Technical Service Bulletin

Number KT2007040401

**Sorento/Sedona Throttle Position Sensor W/3.5L Engine
(Fuel System - 013)**

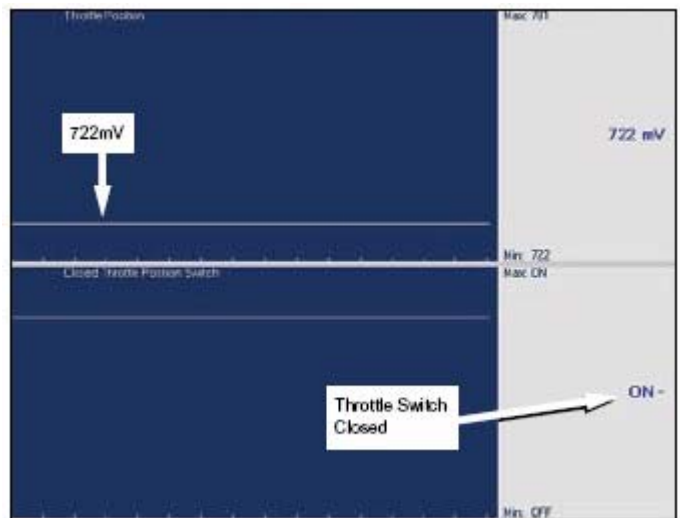
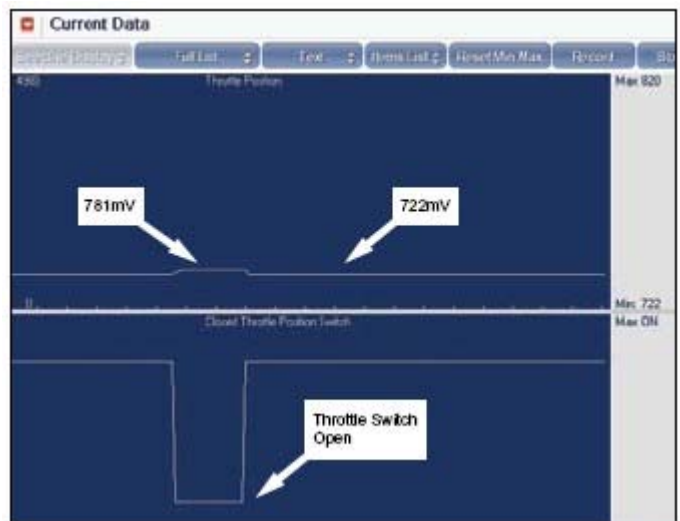
8. Open throttle by hand very slowly until idle switch status switches to OFF. Note the TPS voltage value.

9. Close throttle and record the TPS voltage.

Closed throttle voltage should be 30~65mV less than the voltage noted in step eight (8).

Adjust TP Sensor and repeat test as required.

- Open Throttle Switch Voltage: 781mV
- Closed Switch Voltage: 722mV (subtract from Open Switch value)

Voltage Difference: .59mV (**Spec:30~65mV**)
